**A RESOLUTION OF THE CITY COUNCIL OF
THE CITY OF MERCED, CALIFORNIA,
ADOPTING THE MERCED VISION 2030
GENERAL PLAN**

**MERCED VISION 2030 GENERAL PLAN
OPTION 3**

Proposed Changes Since August 2010 Public Review Draft

EXHIBIT 1

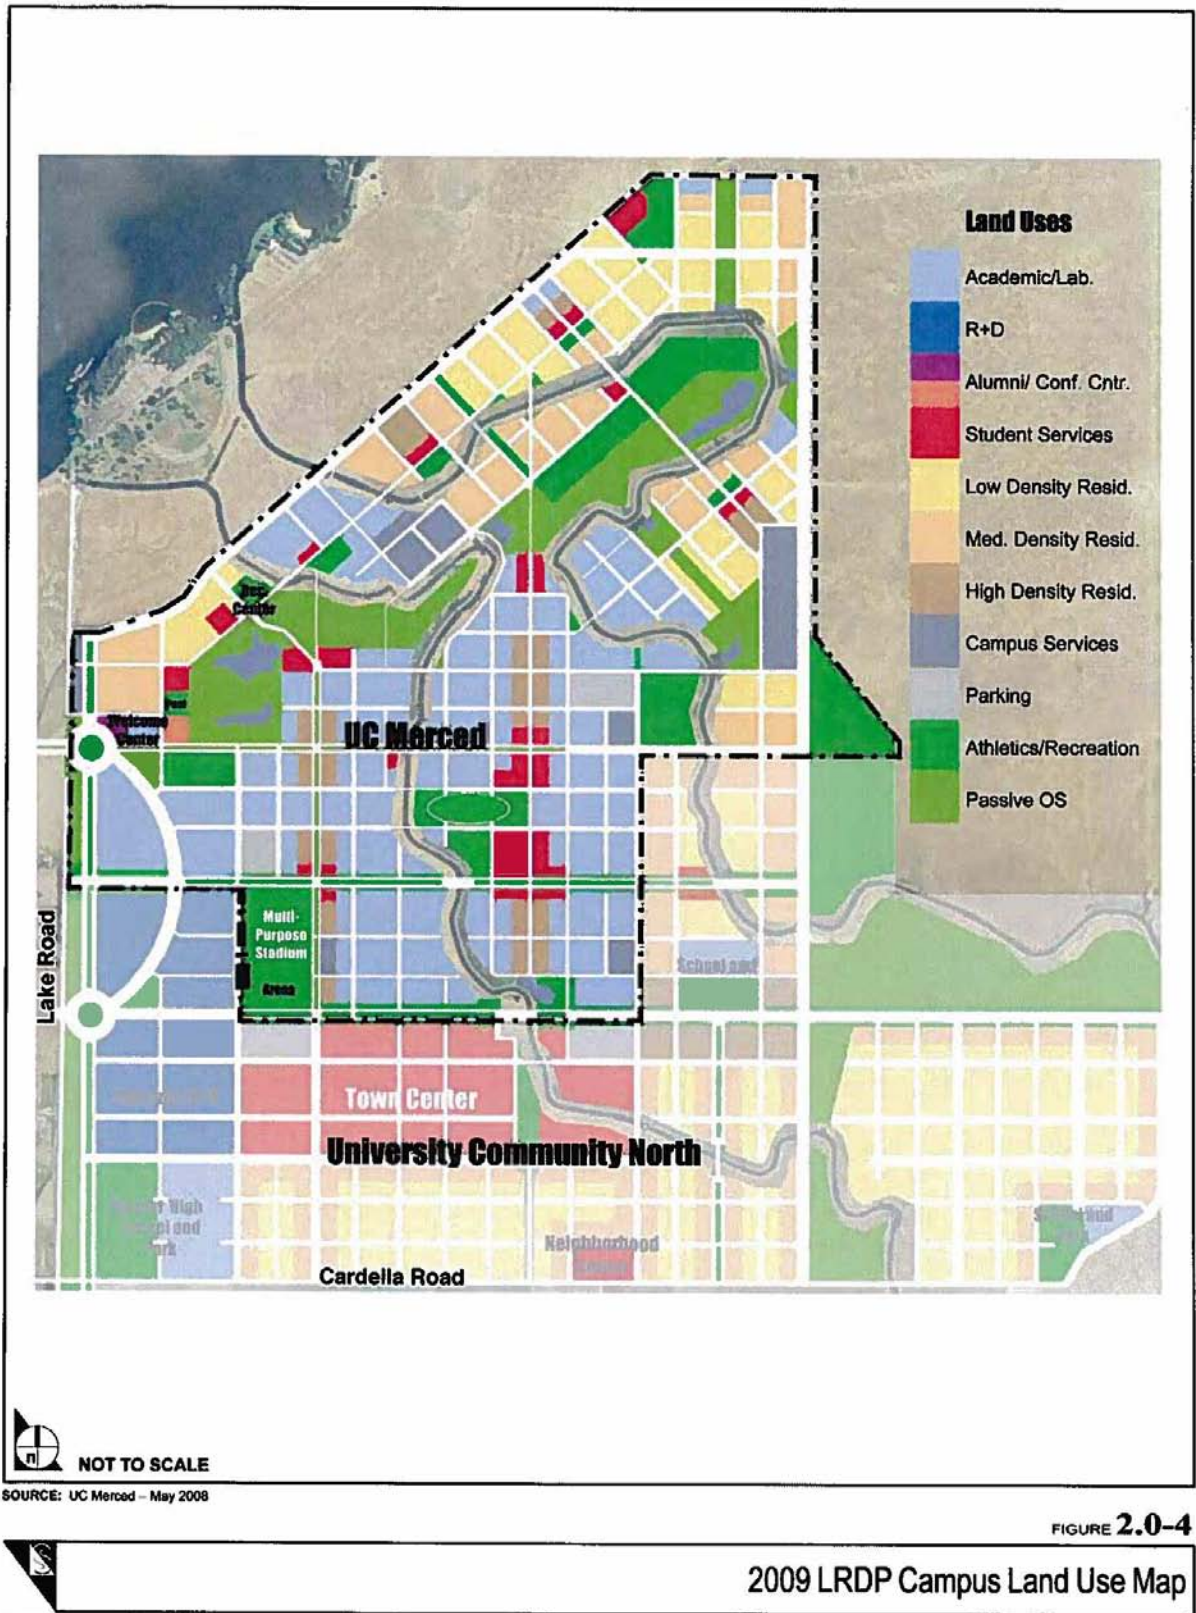
#	Pg.	¶	Col.	Change	Source
1	--	--	--	Various Figures, Maps, and Table throughout the General Plan document will be modified to reflect the 2009 UC Merced and University Community North boundaries as adopted by the UC Board of Regents in 2009. This will include changes to the Land Use Diagram and SUDP/SOI boundary for those areas only. See Exhibit 1 for the 2009 UC/UCP boundaries.	CS/UC

Figure 4.27f
Yosemite Avenue (East of Parsons/Gardner) Special Section

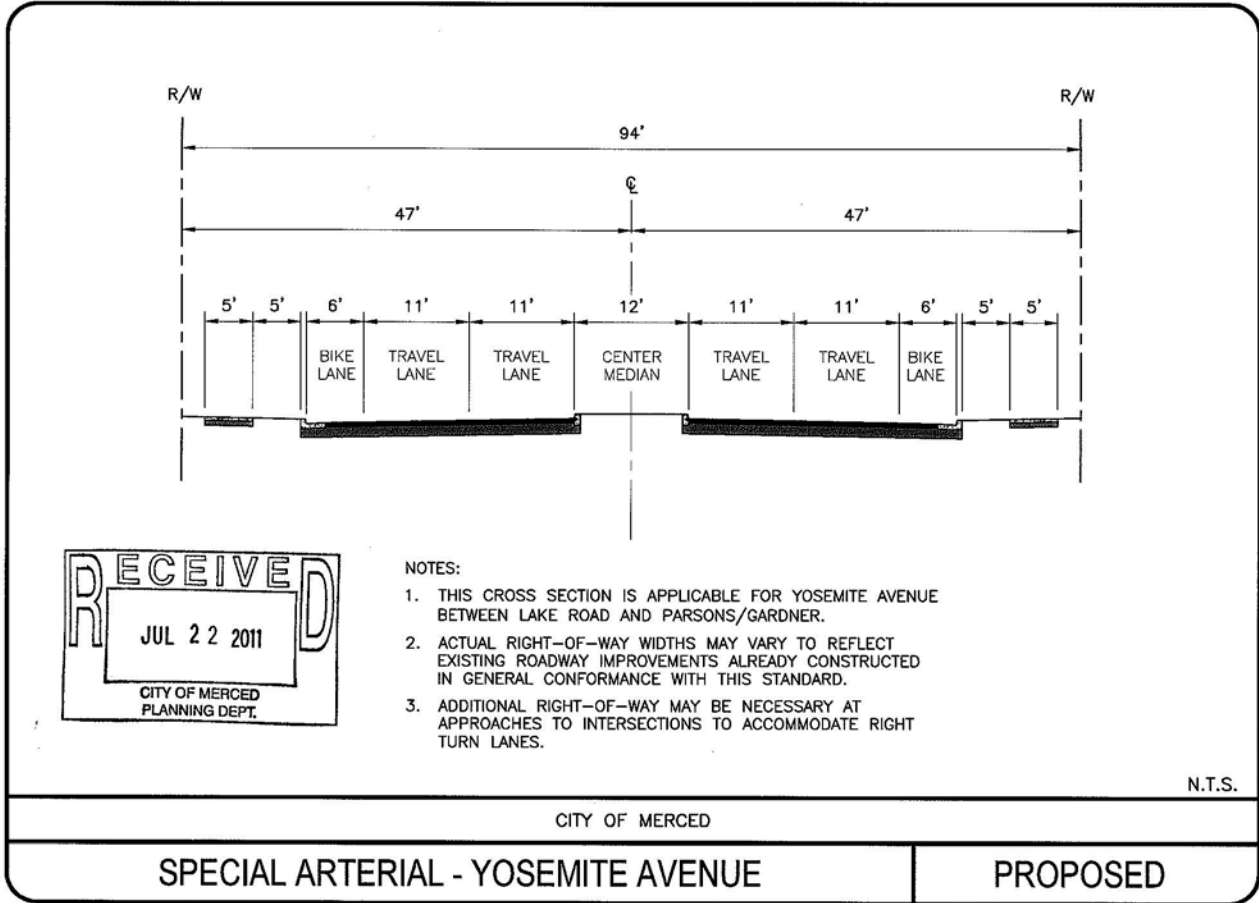
- NOTES:
1. THIS CROSS SECTION IS APPLICABLE FOR YOSEMITE AVENUE BETWEEN LAKE ROAD AND PARSONS/GARDNER.
 2. ACTUAL RIGHT-OF-WAY WIDTHS MAY VARY TO REFLECT EXISTING ROADWAY IMPROVEMENTS ALREADY CONSTRUCTED IN GENERAL CONFORMANCE WITH THIS STANDARD.
 3. ADDITIONAL RIGHT-OF-WAY MAY BE NECESSARY AT APPROACHES TO INTERSECTIONS TO ACCOMMODATE RIGHT TURN LANES.

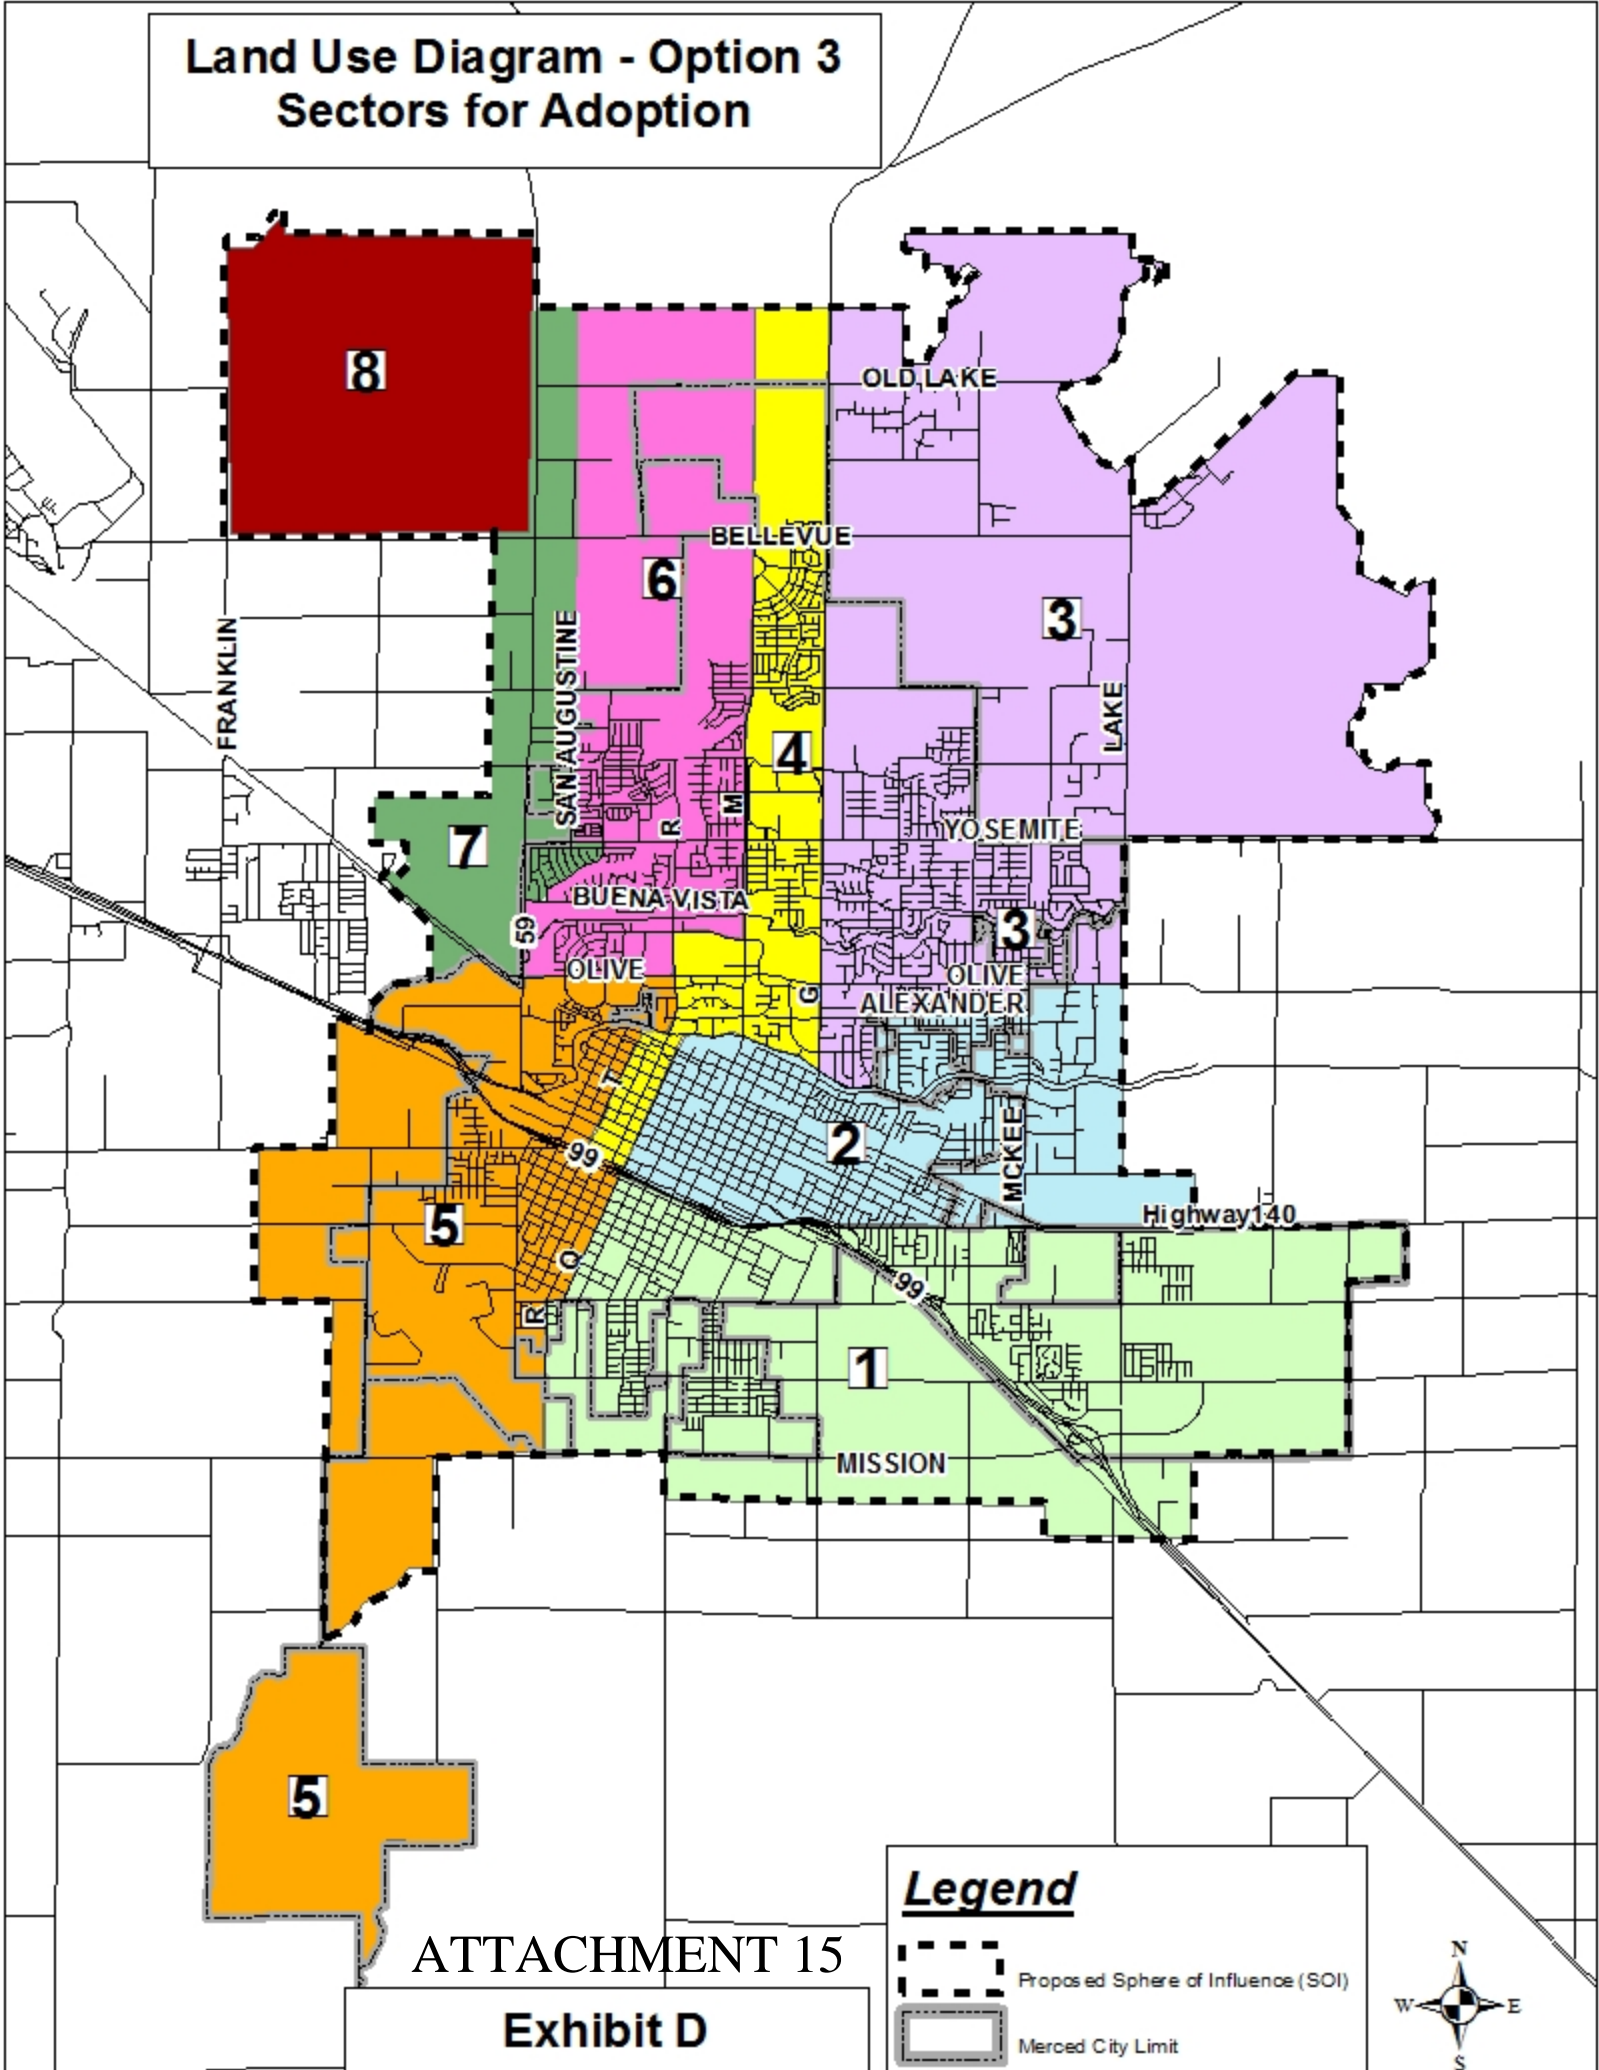
#	APN#	Location	Designation on Land Use Diagram (8/24/10)	Corrected Designation	Source
1	52-300-021 52-300-024 52-300-26 60-010-001 60-020-007 (UC 815 acres & Univ Comm North 833 acres)	Northeast and Southeast corners of Bellevue Rd & Lake Rd (UC Merced Campus & University Community)	School and Community Plan	Designations of School (SCH) and Community Plan (CP) remain but the boundaries change per Exhibit 1	The UC Board of Regents adopted an EIR for the revised boundaries for the UC Merced Campus & University Community North on March 25, 2009.
2	057-200-076 (40 acres)	West of Highway 59, north of Santa Fe Drive	Business Park (BP)	Regional/Community Commercial (RC)	Property owner request to retain 1997 General Plan land use designation
3	052-230-083 (58 acres)	Southwest corner of G and Farmland	Low Density Residential (LD)	School (SCH)	GPA #07-02 11-15-2010 CC Res# 2010-89
4	224-212-001, -002, -003, -8, -009, -010, -012, -013 (1.7 acres)	Northeast corner of Bancroft and Cardella	Fire Station (PG)	Low Density Residential (LD)	GPA #08-03 8-2-2010 CC Res #2010-71

5	058-020-058 (2.5 acres)	Southeast corner of Hwy 59 & Buena Vista	Business Park (BP)	Neighborhood Commercial (CN)	GPA #09-01 5-18-2009 CC Res #2009-37
6	058-290-036 (1 acre)	South of Yosemite, east of R Street	Low Density Residential (LD)	Business Park (BP)	GPA #09-02 8-17-2009 CC Res #2009-60
7	231-010-009 (42 acres)	Southwest corner of Gardner and Cardella	Low Density Residential (LD)/Low Medium Density Residential (LMD)	Commercial/Professional Office (CO) & Low Medium Density Residential (LMD)	GPA #09-03 11-16-2009 CC Res #2009-81

#	APN#	Location	Designation on Land Use Diagram (8/24/10)	Corrected Designation	Source
8	030-204-007, & -008 (15,000 SF)	Southwest corner of W 24 th and G Streets	High Medium Density Residential (HMD)	General Commercial (CG)	GPA #10-01 3-15-2010 CC Res #2010-21
9	231-040-004, -005, -006 (11.5 acres)	Northeast corner of Yosemite & G	High Medium Density Residential (HMD)	Commercial/ Professional Office (CO)	GPA #10-02 8-2-2010 CC Res #2010-73
10	006-061-005 (14,000 SF)	North of Donna/East of G Street (PD #26)	Low Density Residential (LD)	Commercial/ Professional Office (CO)	GPA #10-04 11-15-2010 CC Res #2010-100
11	Not Applicable	Kibby Road (between Childs & Gerard Ave)	Collector Street shown from Childs to Gerard	Kibby Road has been vacated from Childs to Gerard	GPA #06-01/ Vacation #06-01 9-28-2009 CC Res #2009-69/ CC Res #2009-70
12	007-350-005, -006, & -007 (8.8 acres)	Southwest corner of West Olive Ave & G Street	Neighborhood Commercial (CN)	Regional/ Community Commercial (RC)	GPA #11-01 9-6-2011 CC Res #2011-59

13	065-080-020, -021, -022, -029, -035, -036, -048, -049, -052 thru -058, -060, -062, & -063; 065-090-003, -004, -006, 008, -009, 012 thru -024 (Approx. 2,500 acres)	Southwest corner of South Highway 59 & Mission Ave (Mission Lakes)	Community Plan (CP), within SUDP/SOI boundary	Area of Interest (AOI), outside of SUDP/SOI boundary	City Council Direction on 9-19-2011
